**CITY OF CHARLOTTESVILLE
BOARD OF ARCHITECTURAL REVIEW
STAFF REPORT**

Certificate of Appropriateness Application

602-616 West Main (612 West Main), TMP 290003000

Project: New, mixed-use building

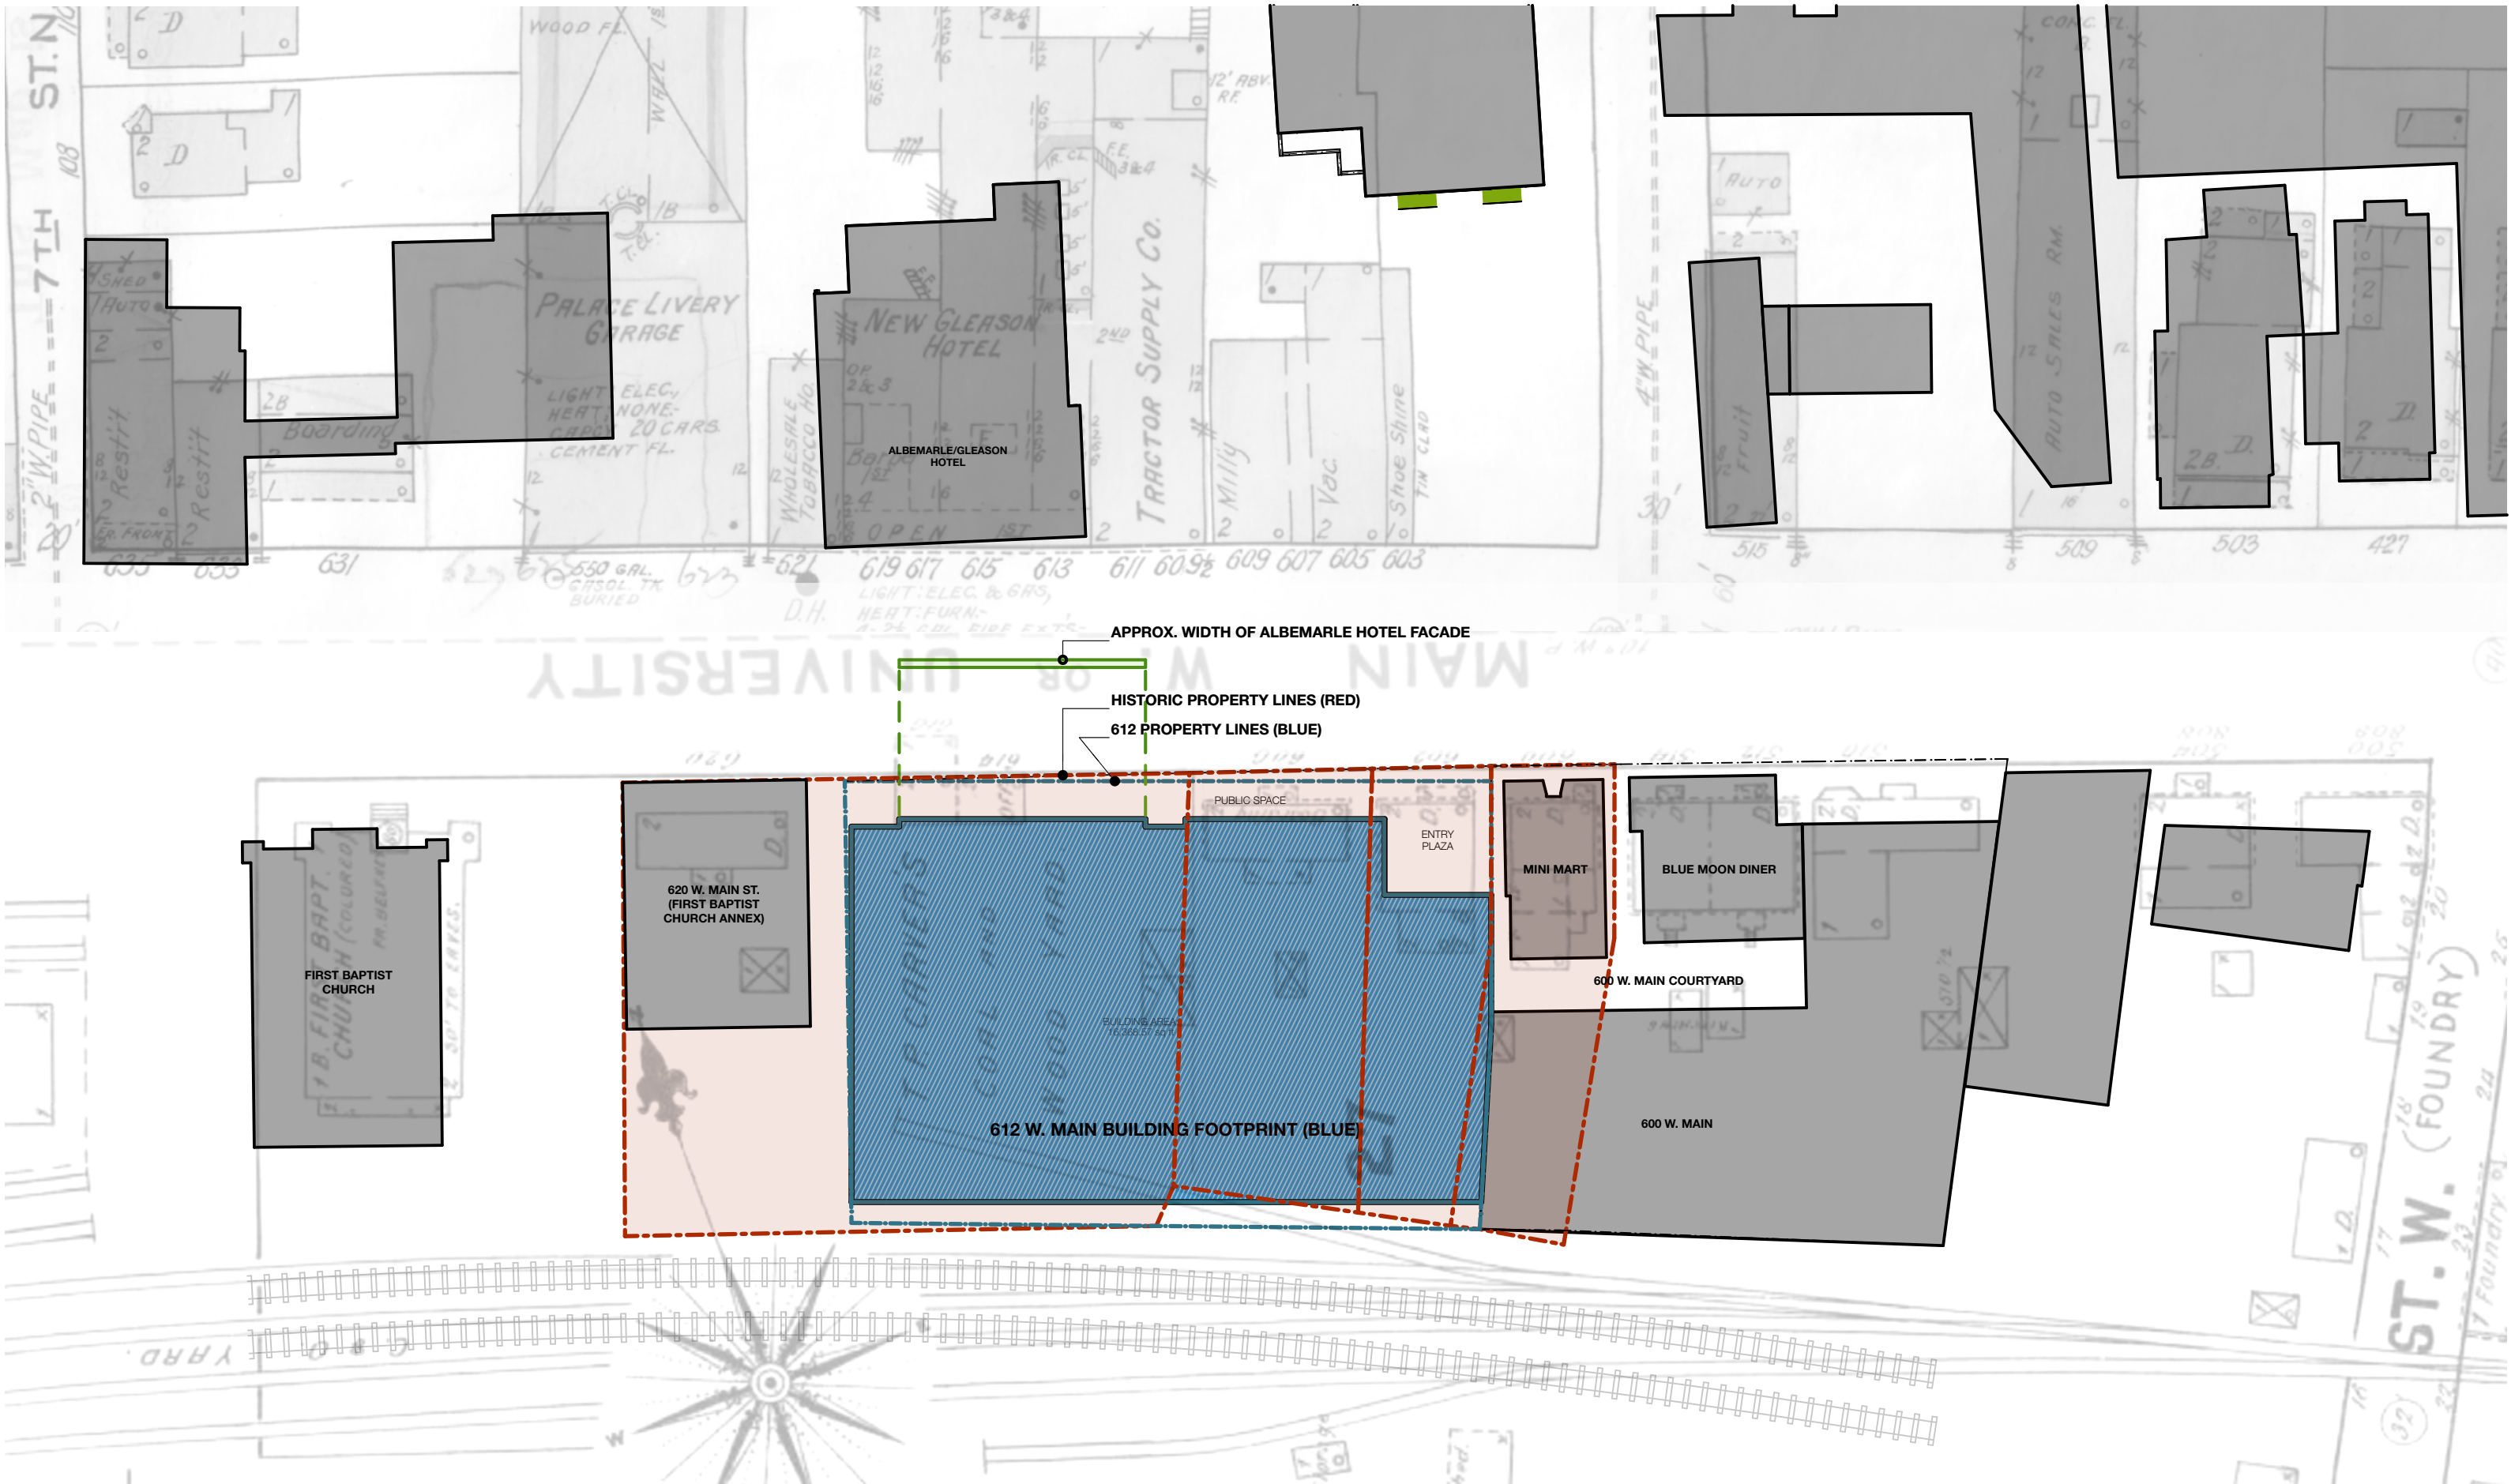
- This site is an anomaly in this district - it's longer than most any other parcel. Horizontality vs. verticality is a critical issue to be resolved. The resolution will set a precedent for the district.

- No clear consensus that horizontal emphasis in the elevation is preferred over verticality. Some members would like to see more verticality; others think that the horizontality of the facade is appropriate.

- Concern expressed about the institutional feel of the facade. Tall, 2 story brick "columns" between pairs of windows reads as monumental and not residential in scale.

- The long planters are an impediment to engagement with the sidewalk for retailers.
- Columnar trees aren't enough to break up the facade into vertical components, and there is no precedent for them on West Main Street. Trees should be coordinated with the West Main Street Streetscape plan.

- One member would like color introduced to the facade to enliven it, noting that most buildings on WMS have color and offer visual interest along the street.

- The addition of balconies would speak to the residential use of the upper floors and increase engagement with WMS.
- Looking for increased verticality, is it possible to extend the facade above the railing height of the 4th floor terraces to allow for variety up to 4 floors in height?
